App'n. Serial No. 10/721,895
Filed: November 26, 2003
Docket No.: 8932-803-999
CAM No.: 232200-999210

REMARKS

This amendment is submitted in response to the non-final Office Action mailed November 29, 2005. Following entry of this amendment, claims 1-46 will be pending in the application. In the Office Action, the Examiner:

Amendment Dated Feb. 28, 2006
Reply to Nov. 28, 2005 Office Action
Annotated Drawing Sheet Showing Changes

Fig. 1

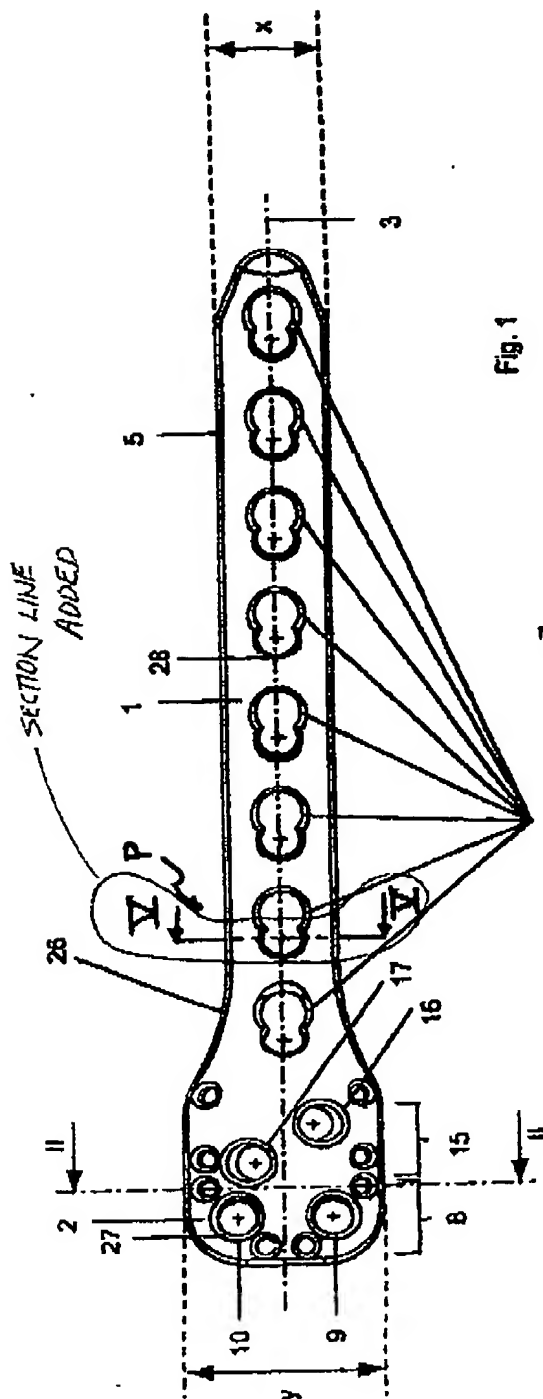
- objected to the drawings under 37 C.F.R. § 1.83(a) as not showing the claimed "double threaded" hole;
- rejected claims 5 and 34 under 35 U.S.C. § 112 as indefinite in using the term "double threaded";
- rejected pending claims 1, 2, 6, 7, 10-12, 18, 19, 21-25, 28, 29, 32, 36 and 39 under 35 U.S.C. § 102(e) as anticipated by U.S. Patent No. 6,623,486 to Weaver et al. (hereinafter "Weaver");
- rejected pending claims 3, 4, 8, 9, 13-17, 20, 26, 27, 30, 31, 33, 35, 37, and 38 under 35 U.S.C. § 103(a) as obvious in view of Weaver and the knowledge of one of ordinary skill in the art; and
- rejected pending claims 5 and 34 under 35 U.S.C. § 103(a) as obvious in view of Weaver in combination with U.S. Patent No. 6,572,622 to Schafer et al. (hereinafter "Shafer").

The Examiner has objected to the drawings as not showing the "double threaded" hole recited in claims 5 and 34. (Nov. 29, 2005 Office Action in Appln. Ser. No. 10/721,895 at 2 (hereinafter, "the Office Action").) In response, Applicants have added new FIG. 5, which is a partial cross-section taken through the bone plate shown in FIG. 1, to more clearly show the recited double threaded hole. Applicants have also amended FIG. 1 to include a new section line "V-V," which corresponds to the cross-section shown in FIG. 5. These drawing changes are fully supported by the originally-filed specification. No new matter has been added. Applicants respectfully request approval of amended FIG. 1 and new FIG. 5, and submit that these drawing changes obviate the objections to the drawings.

The attached drawing sheets include an amendment to FIG. 1 and a new FIG. 5. The first sheet includes FIGS. 1 and 2 and replaces the original sheet that included FIGS. 1 and 2. In FIG. 1, a new "section" line, labeled "V-V," has been added. The second drawing sheet includes new FIG. 5, and depicts a cross-section through the bone plate along line V-V, shown in amended FIG. 1. The attached APPENDIX includes a clean replacement Sheet containing FIGS 1 and 2, a clean new sheet with FIG. 5, and an annotated copy of the sheet containing FIG. 1, showing changes.

Applicants have also amended the specification to include reference to new FIG. 5, which shows the claimed "double threaded" hole. Moreover, Applicants respectfully submit that "double threaded" holes and screws (also referred to as "double lead threads") are well-known in the art, and permit multiple threads to engage a fixation element, e.g., a screw. Applicants respectfully submit that the reference to "multithreaded" and/or "double threaded" holes in the specification and claims of the originally-filed specification (Specification at page 8, lines 14-16, 21-23) provides support for these amendments. No new matter has been added. Accordingly, applicants respectfully request entry of these amendments.
